RESPONSE TO QUESTIONS

Response to Questions received on November 15th, 2022:

City of Clarkston Greenway Trail Parcel Identification

Conceptual Trail Alignment Options

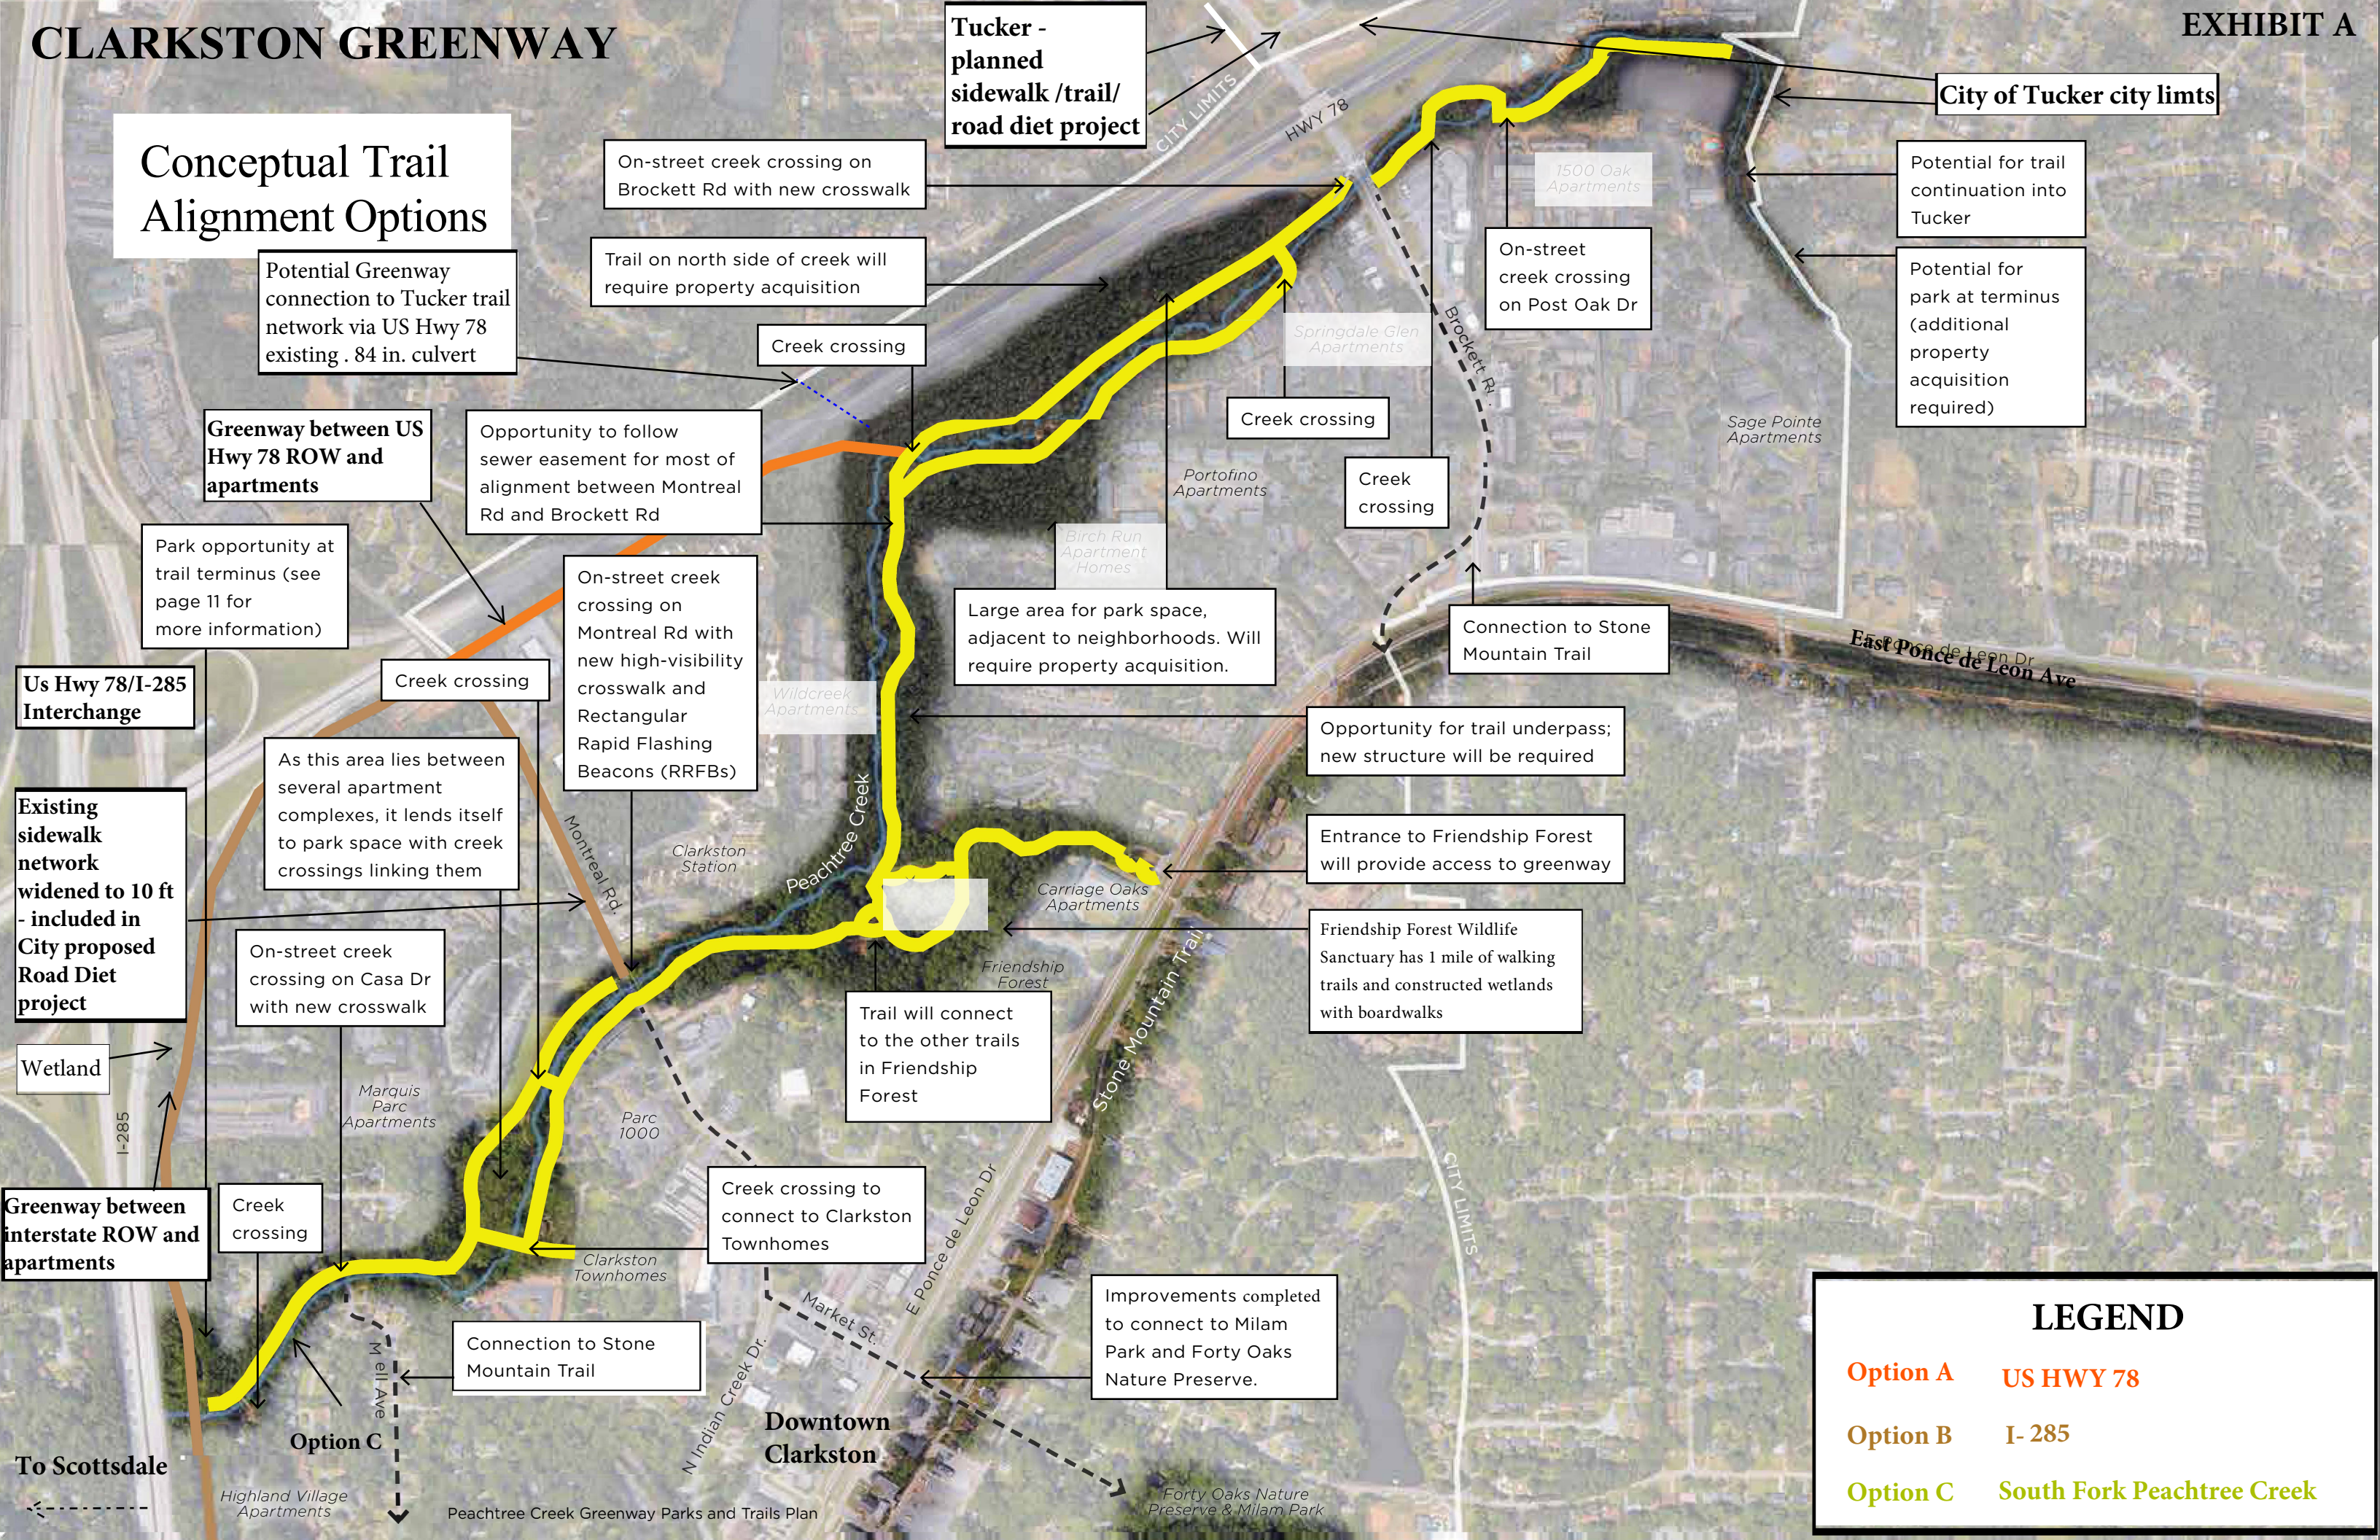
1. Task 1 notes a Survey – “Survey existing conditions of potential greenway locations including significant old growth trees, topography, ROW dimensions, and road crossings.” We want to verify a field-run topographic/tree/ROW survey is not an expected deliverable. Do you want: A) desktop analysis of GIS data and visual survey of existing conditions in the field along studied routes, or: B) a full field-run topographic and existing conditions/tree/ROW survey of the preferred corridor, which could be upwards of 30 acres?

1. Limited GIS data exists but utilizing the county’s GIS geospatial files, in combination with a visual survey on both proposed routes, will be adequate. The visual survey needs to include approximate physical constraints and existing conditions of various features such as number of specimen (trees that are twenty-four inch caliper and greater, waters of the state, significant topographic features (ditches/ravines), utility’s, and other infrastructure such as driveways, fences, billboard signs, etc. It should be noted that the two potential preferred trail alignments included in the ARC grant application are the 2 routes to be assessed. See the attached potential trail routes – Exhibit A

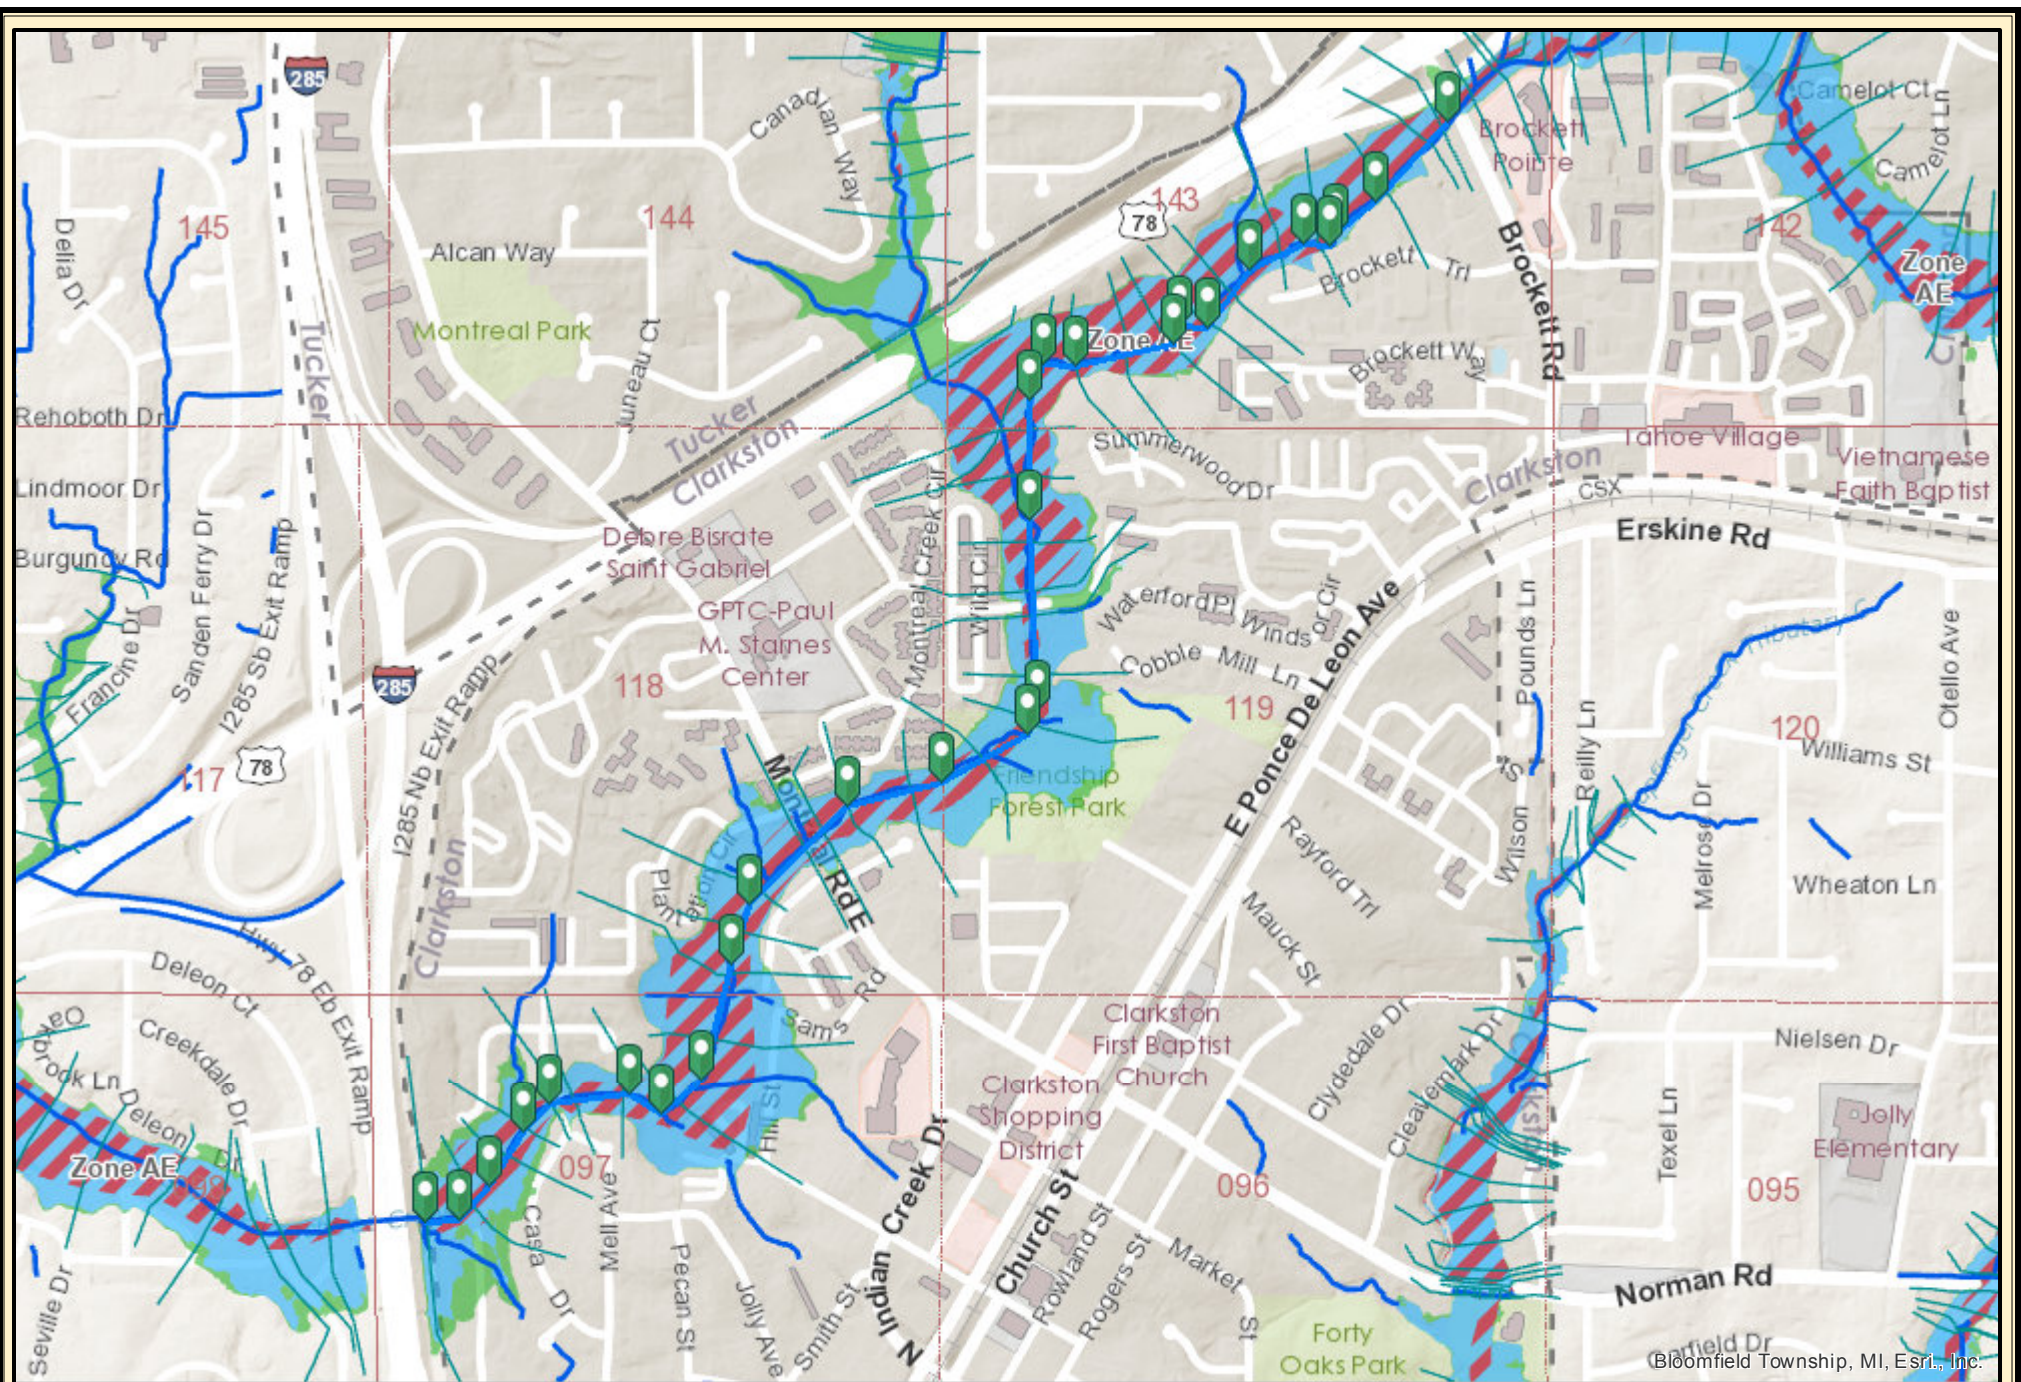
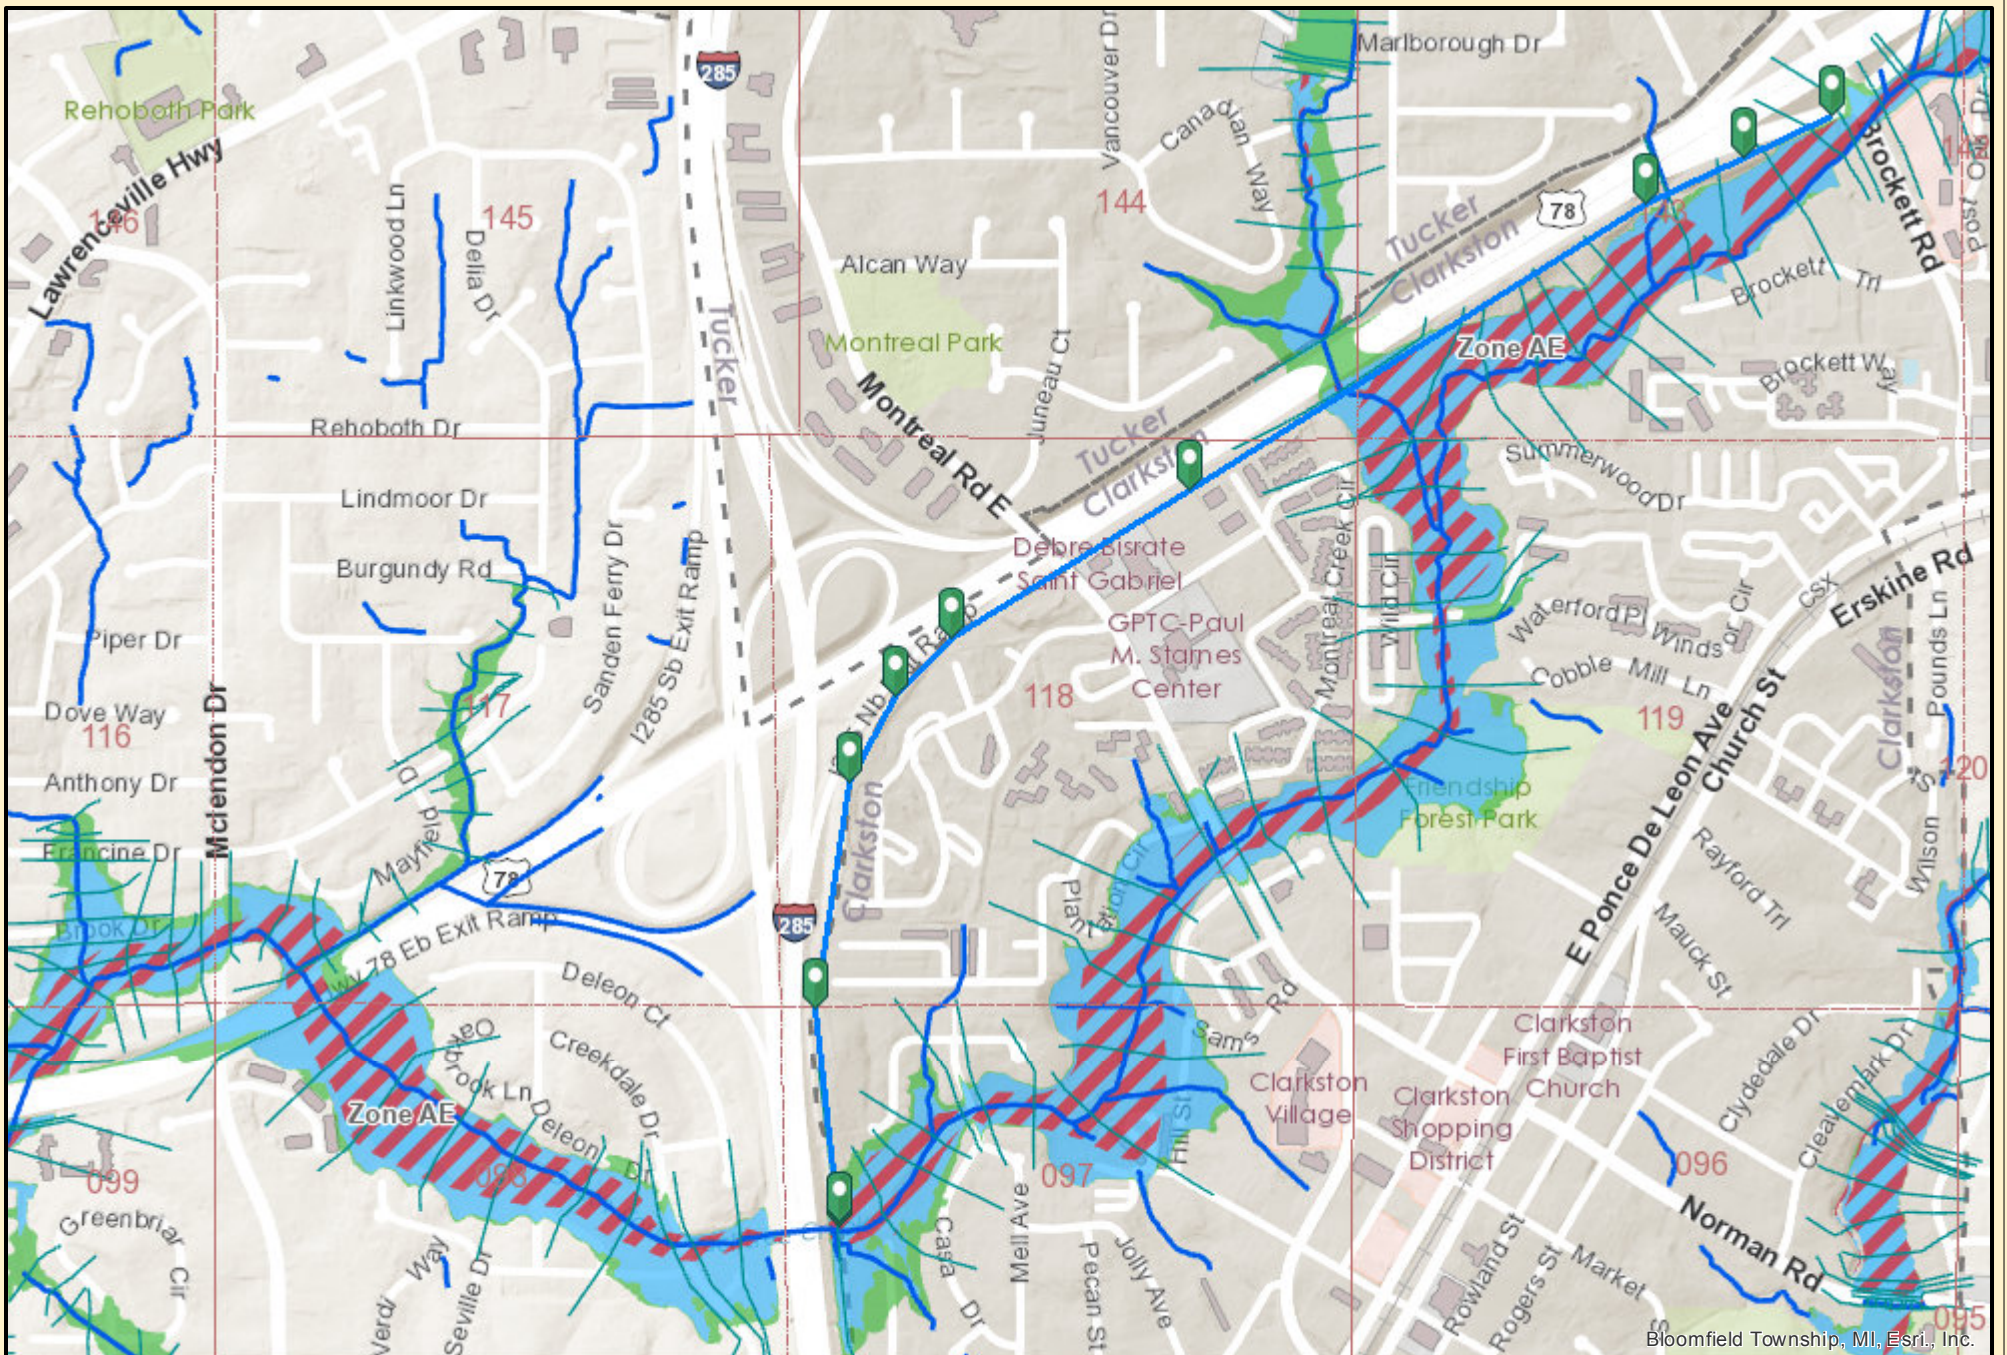
2. Will the City be able to provide right-of-access along proposed trail routes that are on private property for the existing conditions survey/ground truthing analysis?

2. Yes – refer to the attached Exhibit B of the ARC grant application which provided a map of parcels potential effected on 78/285 parallel route alignment
